Technical Service Information

THM 4T60-E OIL PUMP PIVOT PIN CHANGE

Figure 1

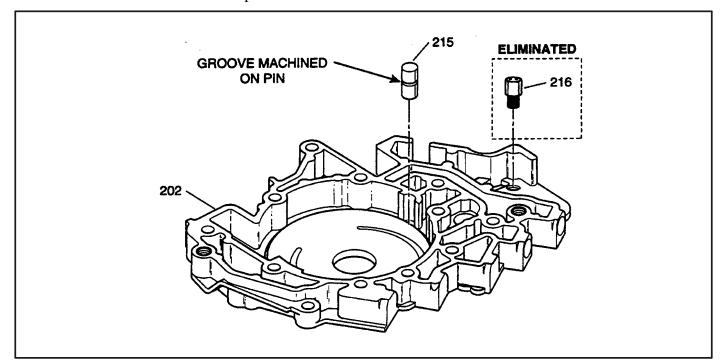
CHANGE: Beginning at Start Of Production for 1993 THM 4T60 and THM 4T60-E transaxles, all

models were produced with a revised oil pump pivot pin and pump casting.

REASON: Cost savings to produce.

- (1) OIL PUMP PIVOT PIN Now has a groove machined around the diameter of the pivot pin to establish the air bleed in the decrease oil circuit, as shown in Figure 1.
- (2) PUMP CASTING The threaded brass air bleed plug that screwed into the pump casting has been eliminated, as shown in Figure 1. This hole is now cast shut.

- (1) When servicing models WITH the brass air bleed plug, the SOLID pivot pin MUST be used.
- (2) When servicing models WITHOUT the brass air bleed plug, the GROOVED pivot pin MUST be used, (See Figure 1).
